HORSHAM DISTRICT COUNCIL CONSULTATION

| LOCATION: | Land To The South of Furners Lane Henfield West Sussex |
| DESCRIPTION: | Erection of 29 dwellings with associated landscaping, open space, parking and creation of new vehicular access |
| REFERENCE: | DC/24/1538 |

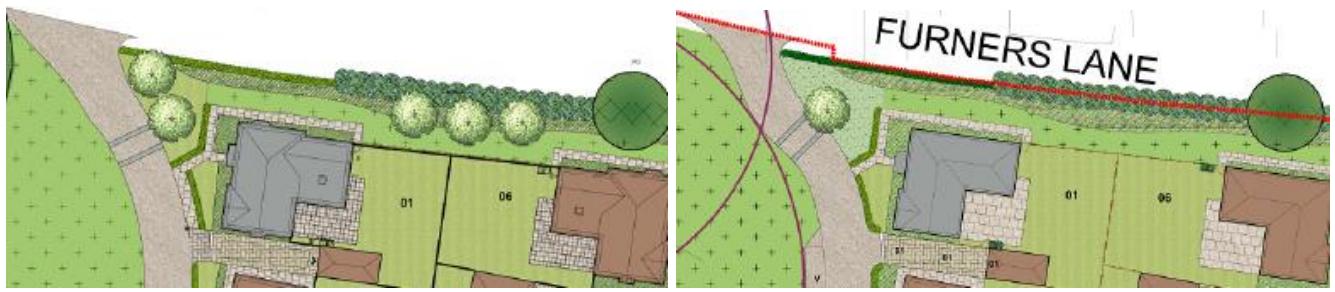
3. Please amend the remaining boundary of plot 9 to brick wall as it is visible and abutting the public realm (highlighted in yellow, below). [Closed, with thanks.](#)

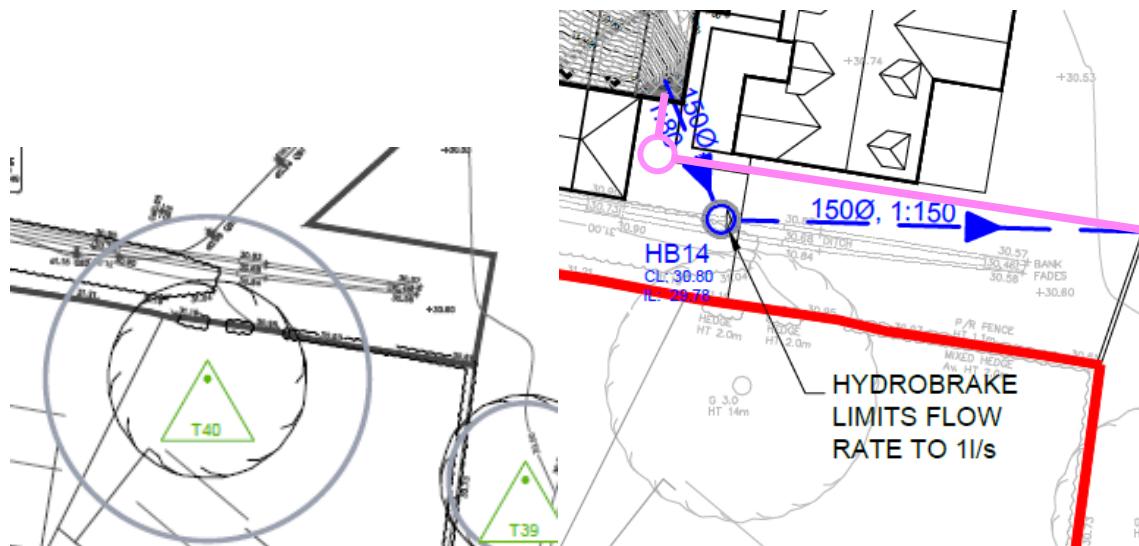
- Opportunities for more tree planting, particularly within the open space that homes the balancing pond, must be explored. [Please see request for reinstatement of reduced trees within summary of comments. We highlight in particular areas visible from Furners Lane, as indicated below.](#)
